D206-642-341BL
Job Sheet 170523-B

Part Name: Replacement Skidtube (Fits LH or RH)

DRAWING NO. D2650	TITLE 206/407 SKIDTUBE ASSEMBLIES	REV. F	DART AEROSPACE LTD ENGINEERING ORDER		D.E.O. NO. D2650-F-1	SHEET NO. SHEET 1 OF 1	SCALE NTS
DRAWN <i>if</i>	CHECKED <i>A.P.</i>	MFG. APPR. <i>AA</i>	APPROVED <i>#</i>		DE APPR. <i>#</i>		
DATE 12.10.12	DATE 12.10.22	DATE 12.10.22	DATE 12.10.22		DATE 12.10.22

CHANGE C'BORED WELDED CROSSBOLT SPACERS TO SWAGED SPACERS

DETAIL G

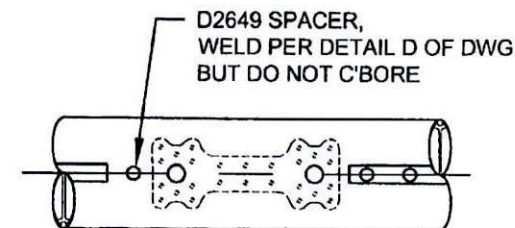
ADD DETAIL G BELOW, WHICH IS THE SAME SECTION VIEW AS DETAIL D OF DWG.

FOR Ø0.375 HOLES ONLY
FOR HOLES THAT ARE CURRENTLY C'BORED ONLY
NOT TO SCALE

AFTER DRILLING AND BENDING ASSEMBLY
PERFORM THE FOLLOWING FOR Ø0.375 HOLES THAT ARE
CURRENTLY C'BORED:

1. INSERT D4720-1 SPACER, 16 PL (-1) OR 17 PL (-3)
OR 19 PL (-5) OR 23 PL (-7)
2. SWAGE TO Ø0.313 X 0.75 DP PER QSI 002
3. TRIM / GRIND FLUSH PER QSI 002

AMENDMENT TO DETAIL B
NOT TO SCALE

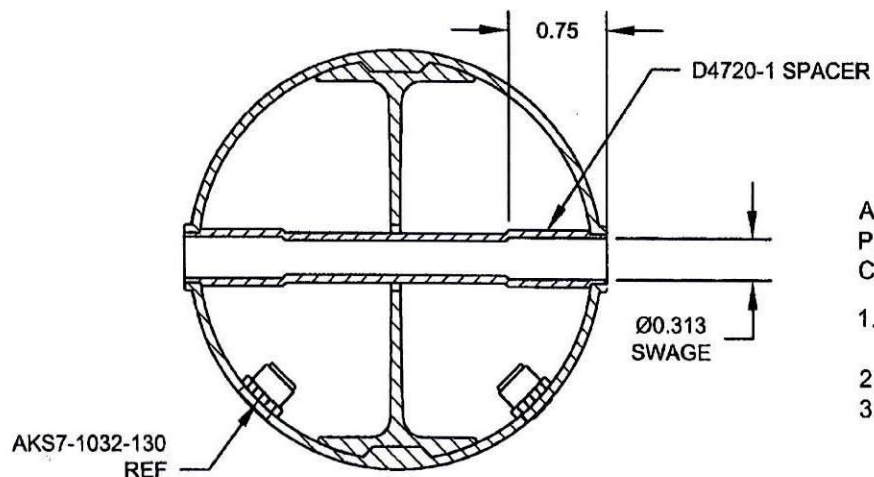
C'BORED HOLES ARE **NOW SWAGED** PER DETAIL G BELOW. FOR THE Ø0.375 HOLE THAT IS NOT C'BORED, WELD PER DETAIL D OF DWG (SEE AMENDED DETAIL B FOR REFERENCE).
